REVISIONS

PROJECT REFERENCE NO. R-3825B	SHEET NO. 22
ROADWAY DESIGN ENGINEER NOT A CERTIFIED DOCUMENT AS TO THE ORIGINAL DOCUMENT	HYDRAULICS ENGINEER NOT A CERTIFIED DOCUMENT AS TO THE ORIGINAL DOCUMENT
THIS DOCUMENT ORIGINALLY ISSUED AND SEALED BY: EDWARD GLENN EDENS, JR. 18470 ON 08/09/2018	THIS DOCUMENT ORIGINALLY ISSUED AND SEALED BY: MEME D. BUSCEMI 037863 ON 08/09/2018
THIS DOCUMENT IS ONLY CERTIFIED AS TO THE REVISIONS.	THIS DOCUMENT IS ONLY CERTIFIED AS TO THE REVISIONS.
DOCUMENT NOT CONSIDERED FINAL UNLESS ALL SIGNATURES COMPLETED	
ROADWAY DESIGN ENGINEER SEAL 024641 Matthew J. York, PE	HYDRAULICS ENGINEER SEAL 043912 Matthew J. York, PE

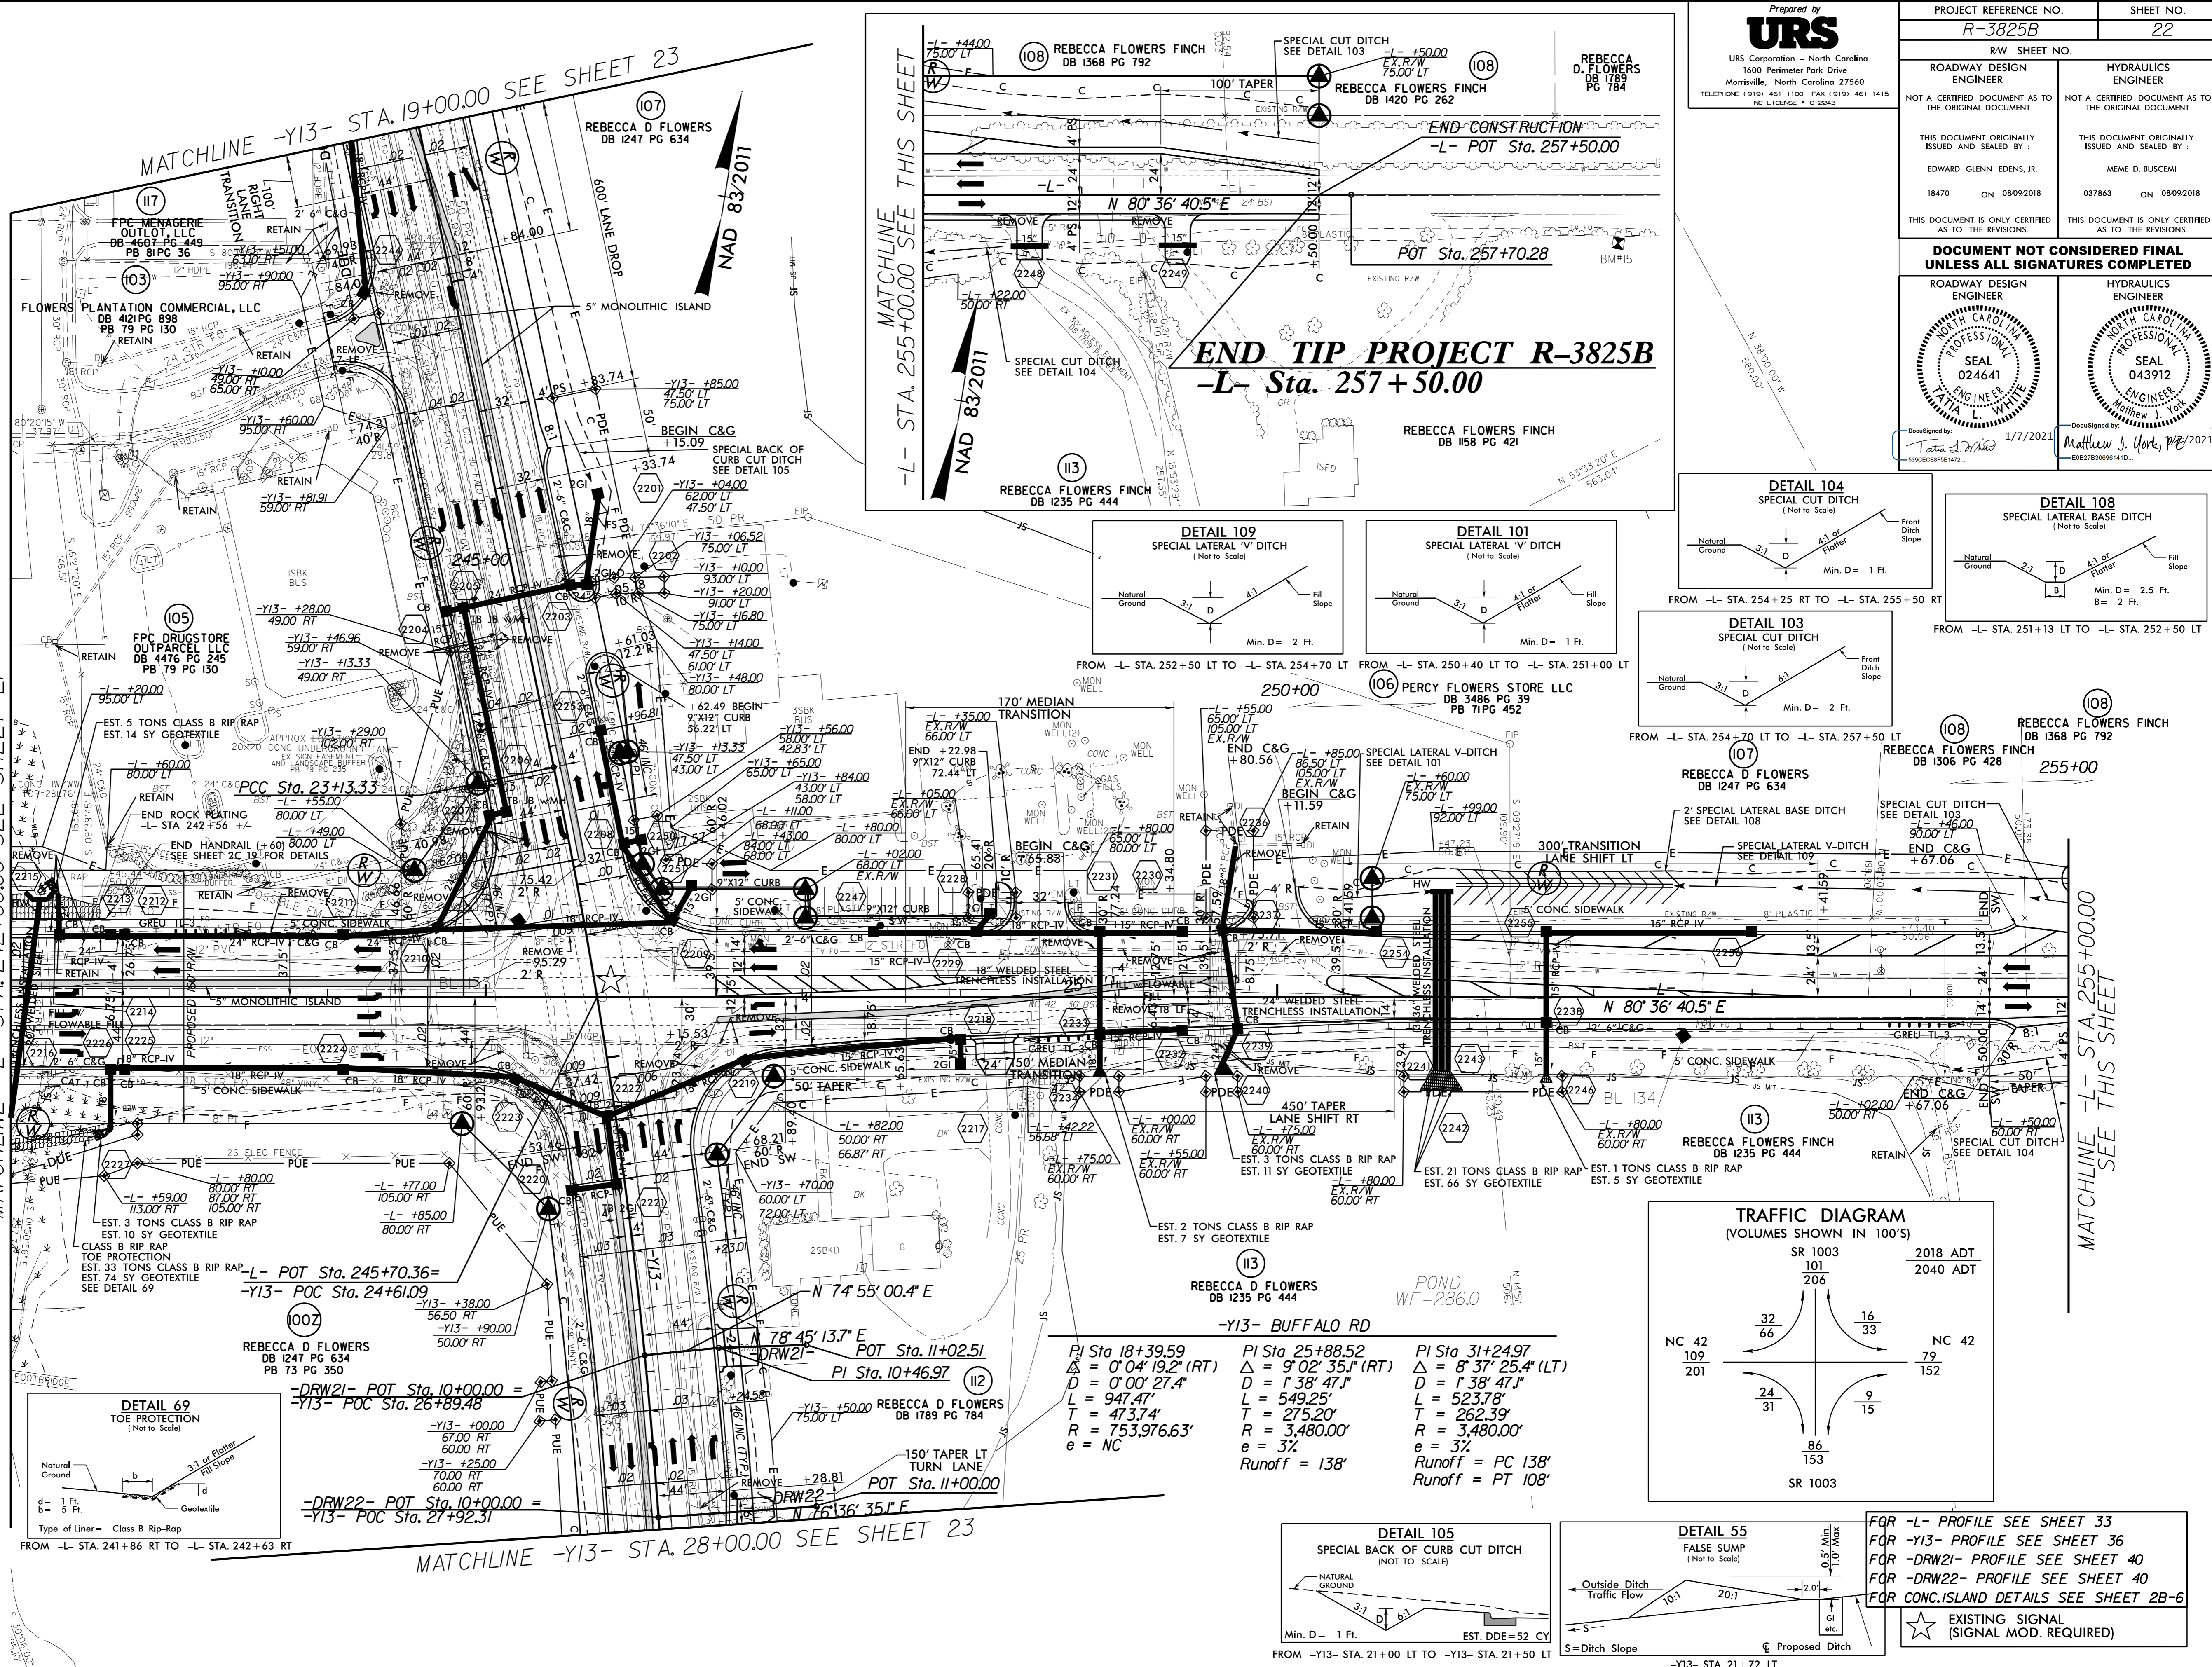
1 - ROW, PUE, PDE, AND EASEMENTS UPDATED ON PARCEL 100 FROM STA. 218+77 TO 244+77 (10/12/2018) TLH
2 - TCE ADDED TO PARCEL 105 FROM -Y13- STA. 20+81.91 TO 22+46.96, 59' RT (11/2/2019) HN
01/08/2021-CONSTRUCTION REVISION: WIDENED BERM, AND ADDED HANDRAIL, STEEPED SLOPE AND ADDED ROCK PLATING, ADJUSTED GUARDRAIL AND DRAINAGE -L- STA. 242+00 TO 242+60.00 LT (HN)
